DESIGN REVIEW BOARD AUGUST 17, 2018

DESIGN REVIEW BOARD

JULY 20, 2018

CITY OF ALPHARETTA DESIGN REVIEW BOARD

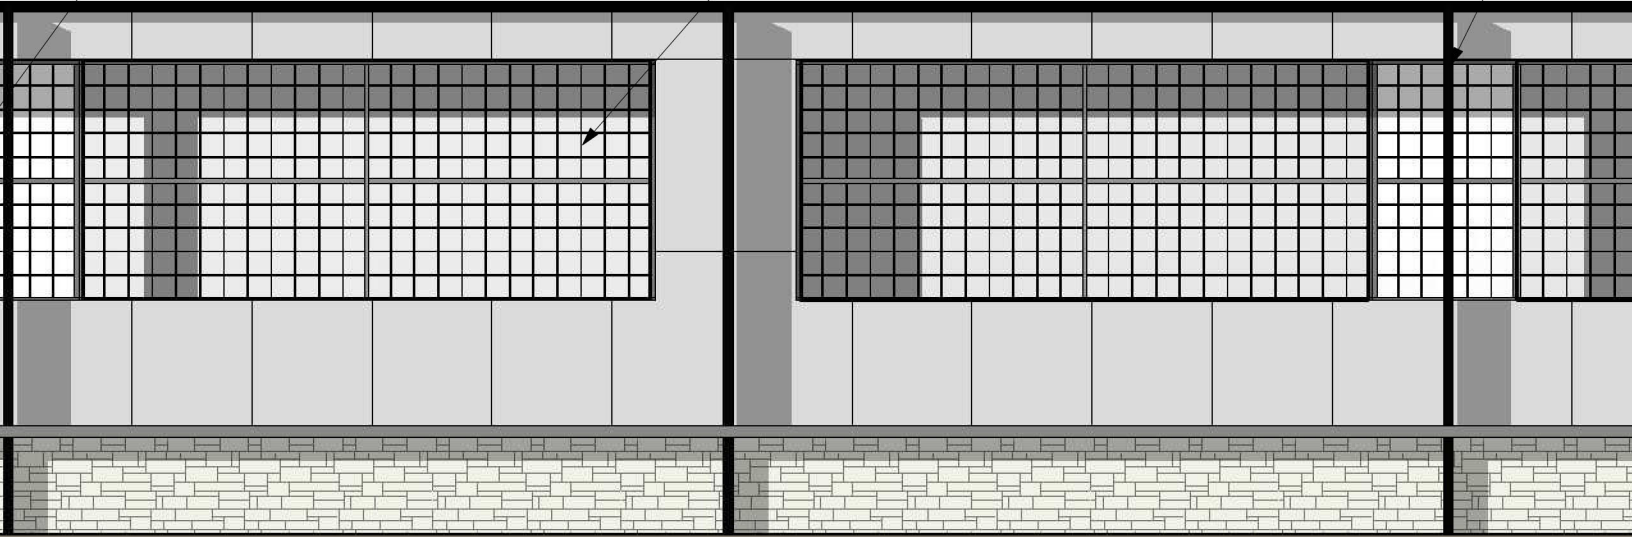
Defer to Comments

- ① Schedule of Building
- ② More details on wall
- ③ Ped walkway
- ④ Ect
